New Airtex Improved Connector and Pigtail for GM Fuel Pump Modules

Airtex Manufactured GM Modules to be converted to 4 X 1 Connector:

OLD DESIGN-TOP & SIDE VIEW

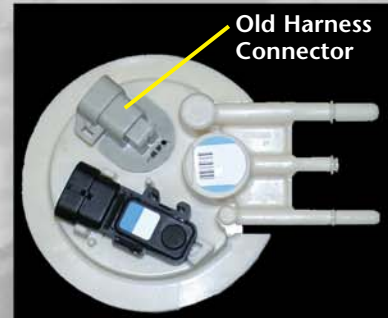
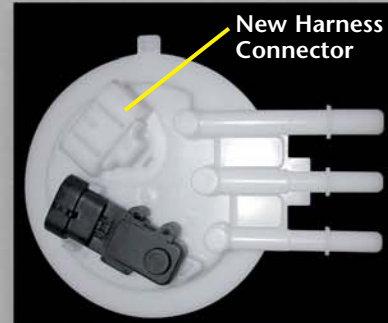
Many GM vehicles from 1988 to 2005 have electrical connectors on the fuel pump module that may become loose over time due to vibration, leading to faulty, high-resistance connections. The symptoms - burned or melted connectors and pins - lead to a voltage drop situation where low or no voltage can cause the module to stop pumping.

GM FUEL PUMP MODULE WITH OLD HARNESS CONNECTOR

GM FUEL PUMP MODULE WITH NEW HARNESS CONNECTOR

Airtex Products' latest fuel system solution provides a quick and reliable fix for burned or melted wiring harness connections on certain GM in-tank fuel pump applications. Airtex has replaced the faulty OEM design connector with a new OEM design that eliminates the burned or melted connectors and pins problem.

Fuel pump modules with the improved 4-pin connector require vehicle harness replacement. One of the five application-specific, color-coded vehicle wiring harnesses is included with every pump that uses the new connector.
